UNITED STATES PATENT AND TRADEMARK OFFICE

APPLICATION NO.	FILING DATE	FIRST NAMED INVENTOR	ATTORNEY DOCKET NO.	CONFIRMATION NO.
10/509,900	08/17/2005	Manfred Malle	Vinazzar 2	2982

Office Action Summary

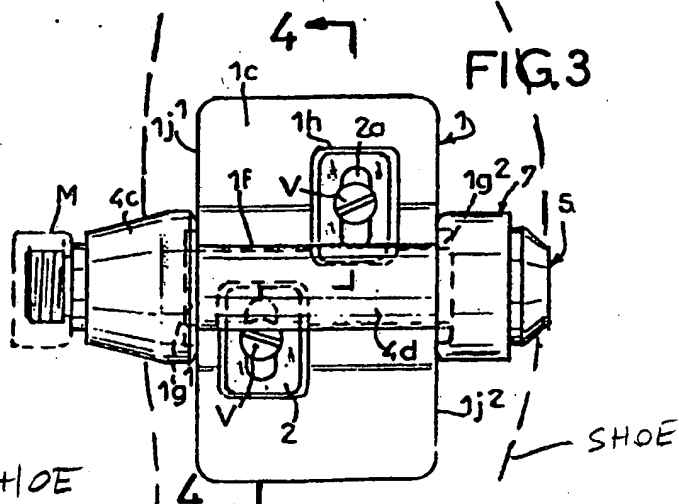
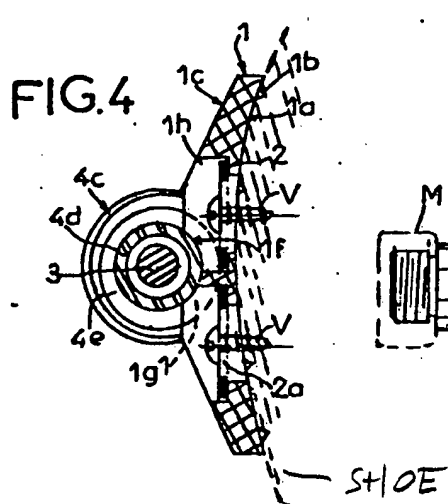
Regarding claim 1, Lyotard teaches a pedal system for bicycles comprising a shoe insert 1, which can be fastened on a shoe (shown by dashed lines, see Attachment hereinafter “Att.”)

and has a detent element $1g^1$, $1g^2$ (FIG. 1) and a pedal 4, which can be fastened on the bicycle and can be rotated about an axis (Att.), and which pedal 4 has a seat 4c, 7 for the detent element $1g^1$, $1g^2$, in which seat said detent element $1g^1$, $1g^2$ can be locked against elastic force, and from which seat 4c, 7 same can be released by carrying out a rotating movement, wherein the seat 4c, 7 is formed between two seat parts 4c and 7, which are designed rotationally symmetrically with respect to the pedal axis (Att.), and which can be moved away from one another against elastic force in direction of the pedal axis (Att.).

Regarding claim 2, the seat parts 4c and 7 form or have receiving grooves 4e and 7c (Att.) facing one another.

Regarding claim 3, one (7) of the two seat parts 4c and 7 can be moved against the force of at least one spring (Att.).

Regarding claim 6, at least one pressure spring (FIGS. 1 and 2, see Att.) is provided as the spring, which pressure spring is supported with its one end on an abutment connected to the sleeve 4c, 4d and with its second end on the second sleeve 7.

FIG.5

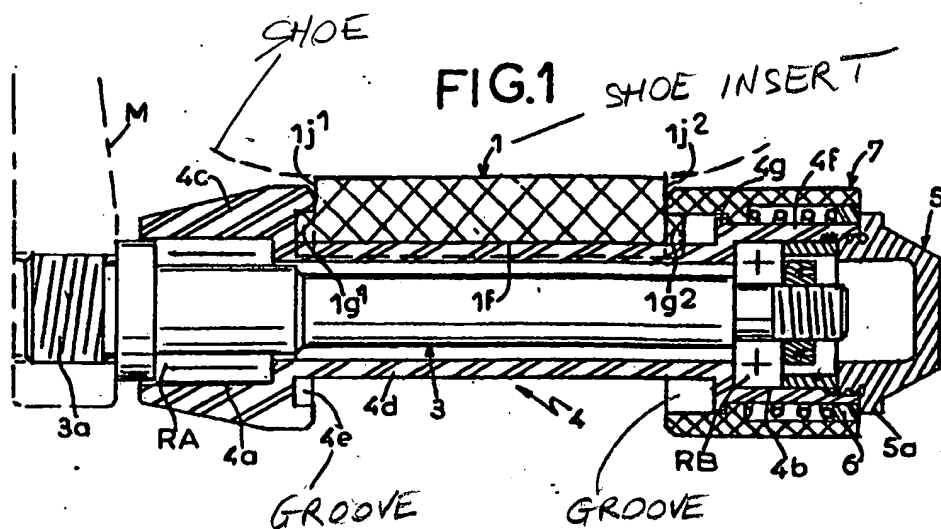
Regarding claim 9, the detent element $1g^1$, $1g^2$ has side surfaces, which have in particular centrally each one cam 1f (FIGS. 5 and 6).
